To: Planning Office Subject: POD2021 - 00113: River Mill – Sec 7
Henrico County Police Division,
From: Community Services Unit Date: April 1, 2021

POD2021-00113

Site Plan Review

Photo A. Shielded wall pack.

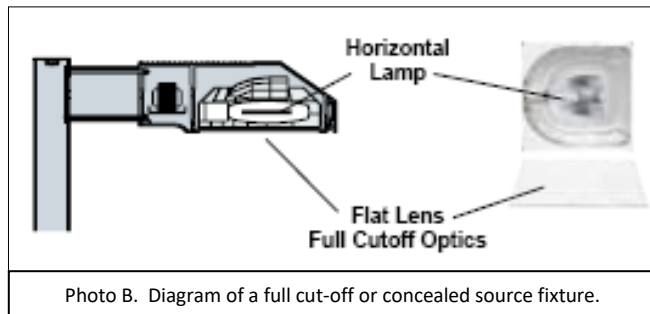
3. All light fixtures need to be full cut-off. See Photo's A and B for examples of full cut-off wall packs and pole lights.
4. Should post top fixtures be used, these fixtures also need to be full cut-off so that the light will be directed down to the ground, versus horizontally and up in the air. If decorative fixtures are installed, they should have the lamp in the top casing of the fixture so that the light will be directed towards the ground (See Photo C). This will also avoid glare because you don't actually see the lamp. Glare is defined as horizontal light that hinders vision.
